## MEMORANDUM

**SUBJECT:** **Cayman Enterprise City PAD Application**

**LOCATION:** **21B/28REM1, 15C/29 and 15C/354**

**Figure 1: Aerial image showing permitted developments (highlighted in red) and proposed developments (highlighted in blue) within the South Sound drainage basin.**

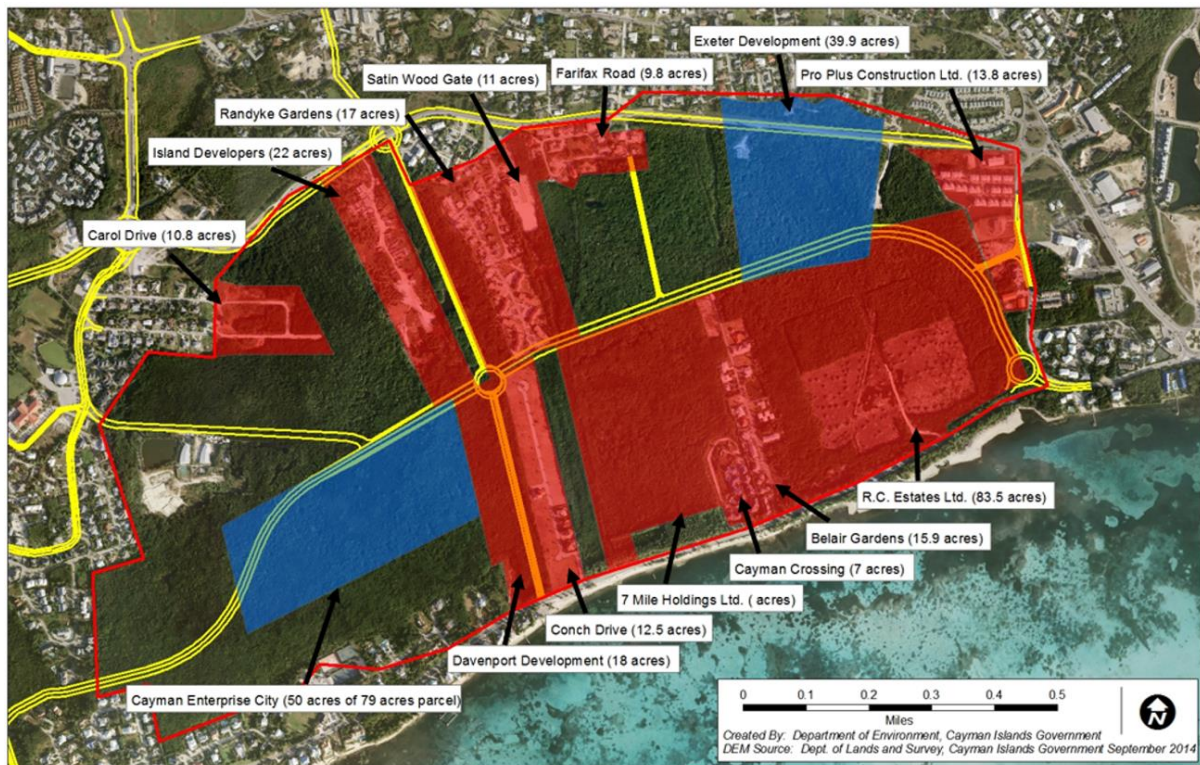
Detailed water level measurements in South Sound have shown that the mean surface water level within the swamp is higher than the mean sea level in South Sound (Davies, J.E. and Giglioli, M.E.C, 1977). During the wet season, impounded rain water remains within the basin and has limited means of escape. As more and more development is brought forward, the implications of removing the stormwater retention capacity of the basin becomes increasingly significant and problematic, due to potential flood risk for properties within the basin. As shown on Figure 1, the current application is only one of a series of developments coming forward in the basin.
